PROPOSED RESIDENCE AT:

325 VIA LINDA

DAILEY JANSSEN ARCHITECTS

ROGER P. JANSSEN AR-14785
ARCOM # ARC-23-014
TC # ZON-23-029

PROPOSED WEST ELEVATION
POOL FOLLY/PERGOLA W/ AWNING

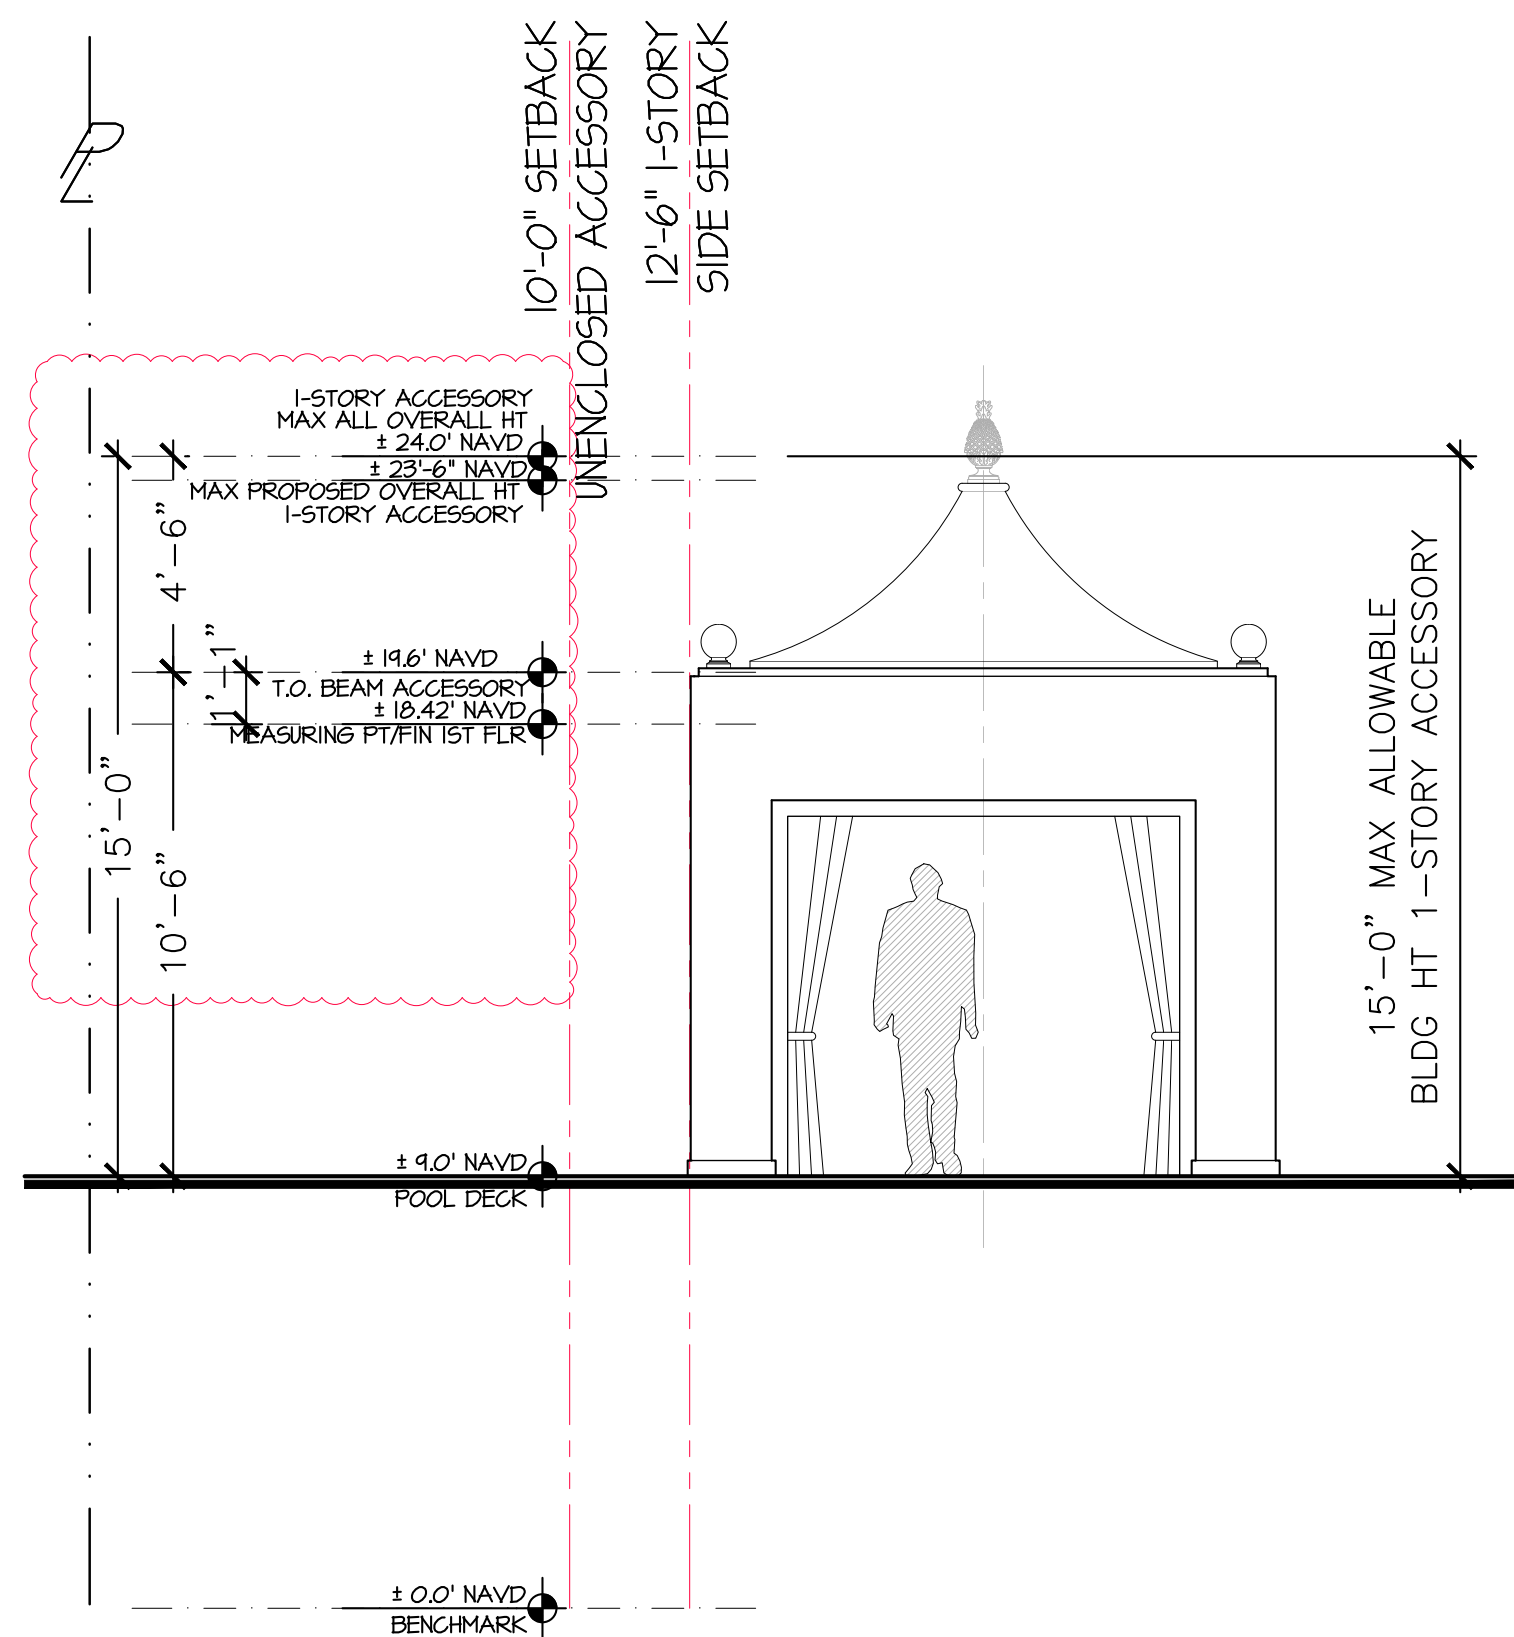
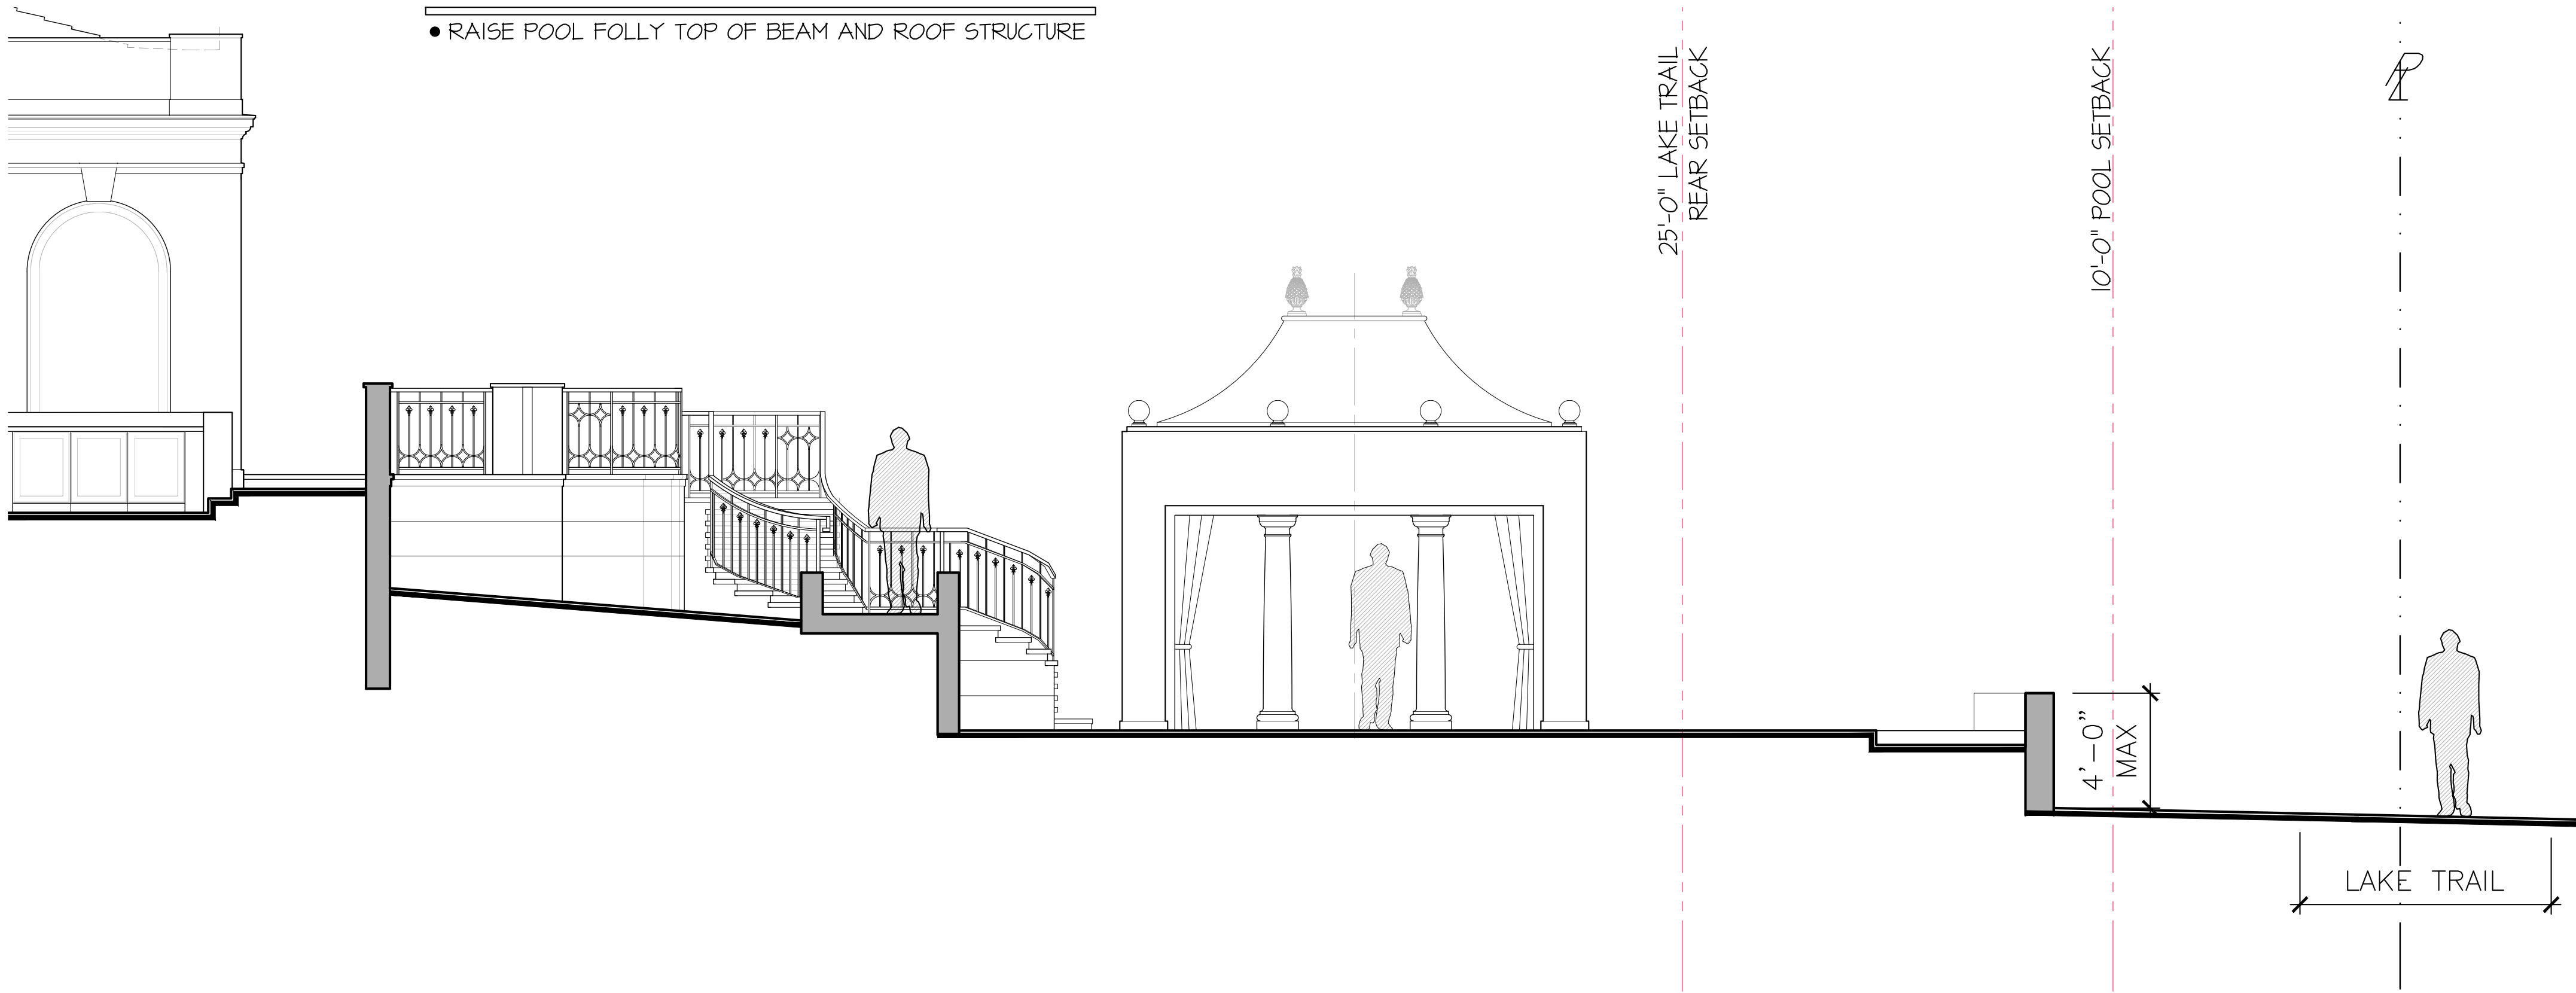
- RAISE POOL FOLLY TOP OF BEAM AND ROOF STRUCTURE

EAST-WEST CROSS SECTION

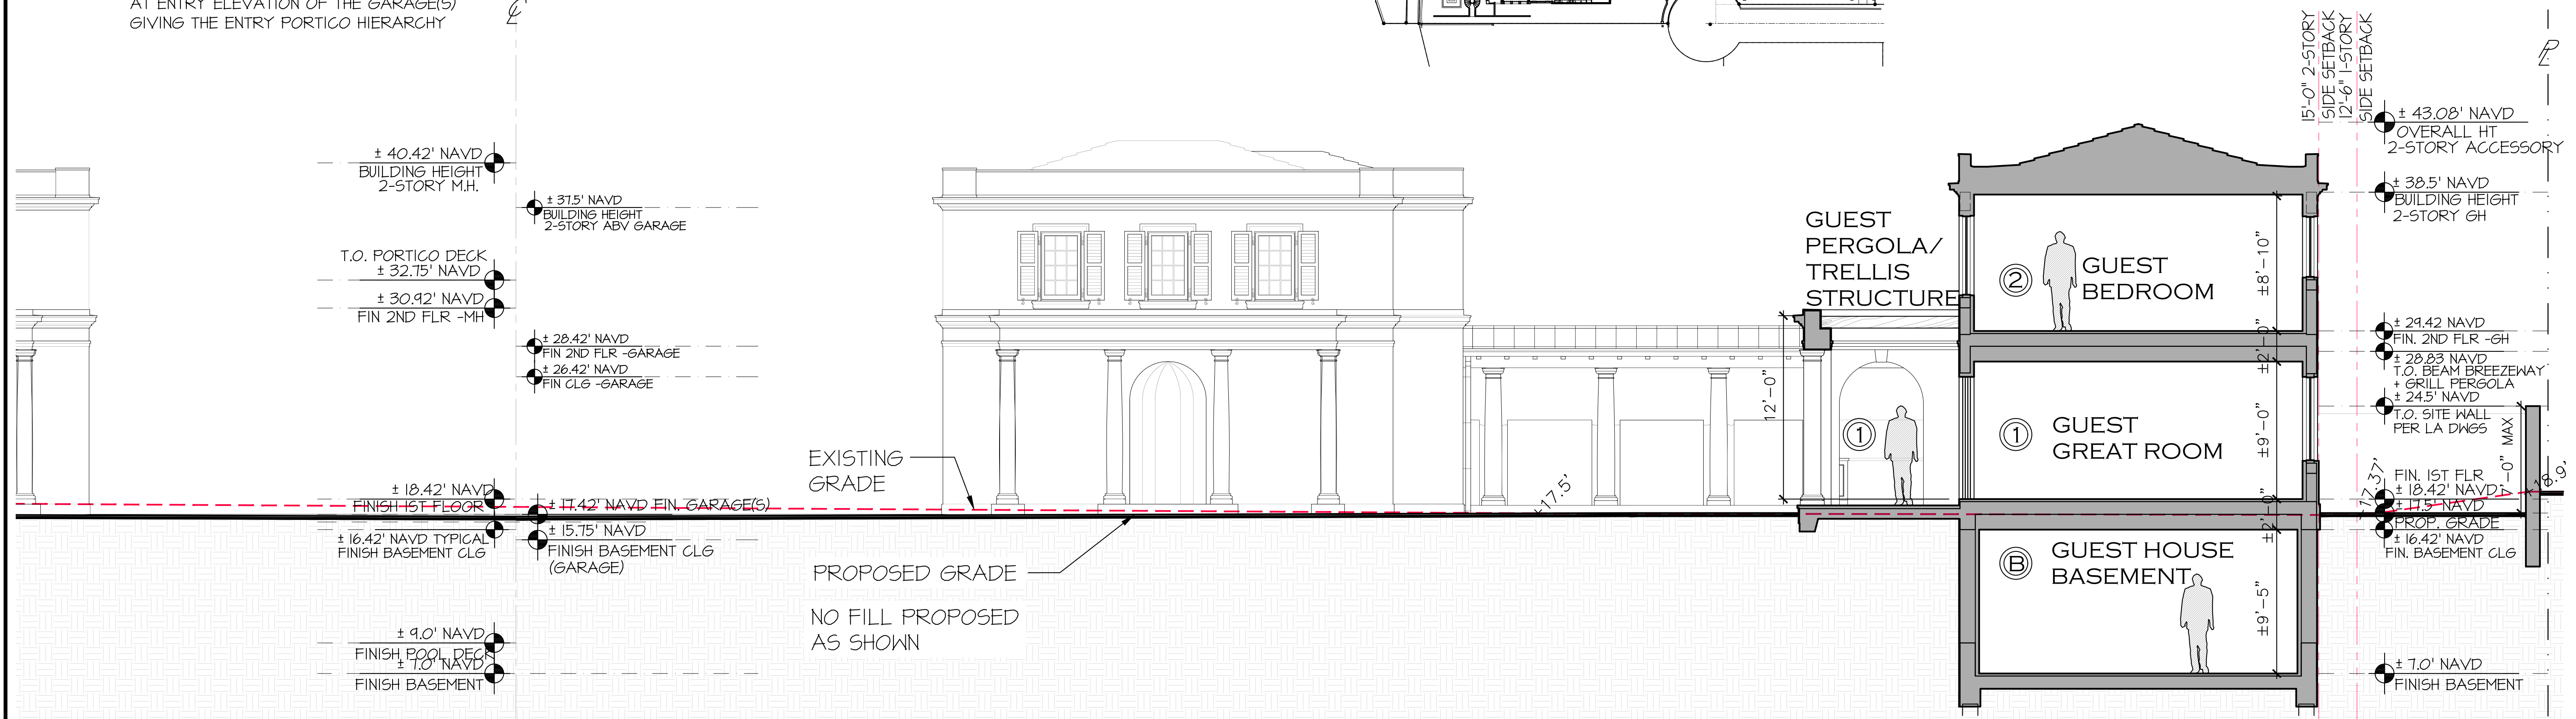
- LOWER PARAPET WALLS AND REVISE ROOF PITCH TO 4:12
